CORRECTIONS FOR EROSION AND SEDIMENT POLLUTION CONTROL PROGRAM MANUAL ID 386-2134-001, March 2012

46 Revise Figure 3.11 as follows:

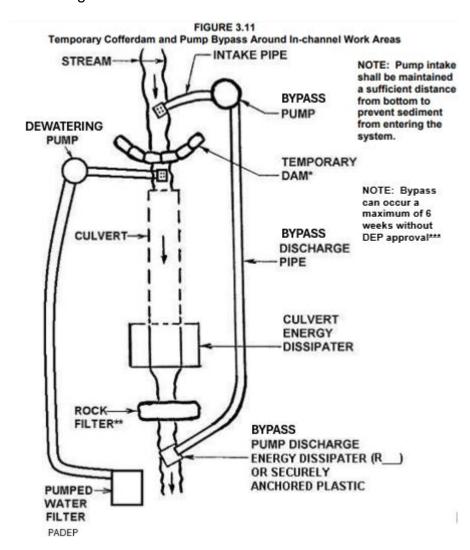
- * Sandbags (Standard Construction Detail #3-15), Jersey barriers (Figure 3.13) or other nonerosive material, no earth fill. Do not excavate a sump for the pump intake.
- ** See Standard Construction Detail #4-14. For low gradient channels, the rock filter may be replaced by an impervious cofferdam to prevent backflow into the work area.
- *** Based on a joint water quality evaluation study conducted by DEP's Bureau of Clean Water and PennDOT's Bureau of Design and Delivery from 2020 to 2024. DEP must approve durations greater than 6 weeks.

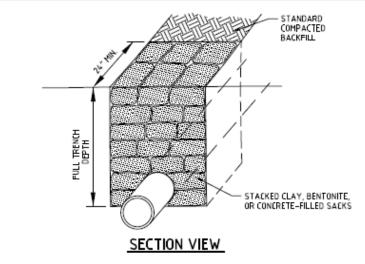
Page(s)	Correction
112, 125, 380	Revise travel time for sheet flow formula to:
	$T_{c(sheet flow)} = \left[\frac{2(L)(n)}{3(S)^{0.5}}\right]^{0.4673}$
124	Revise calculation for 2-year rainfall intensity to:
	$I = \frac{106}{Tc + 17} = \frac{106}{23.24 + 17} = \frac{106}{40.24} = 2.63 \ in/hr$
124	Revise calculation for 10-year rainfall intensity to:
	$I = \frac{170}{Tc + 23} = \frac{170}{23.24 + 23} = \frac{170}{46.24} = 3.68 \ in/hr$
125	Revise Overland Flow Time T_{of} to 11.6 and T_{c} to 23.24.
229	Clarification, in the formula below n = Manning's "n":
	$Q_f = \frac{0.464}{n} D^{8/3} S^{1/2}$
247	Revise formula for the distance (X) in feet from the end of the discharge pipe to the "center" of the basin as follows:
	$X = (V^2/2g)^{0.5} [(1+m/p)^{0.5} + 1 + m/2p] p^{0.5}$
291	Revise Standard Construction Detail #13-4 as follows:
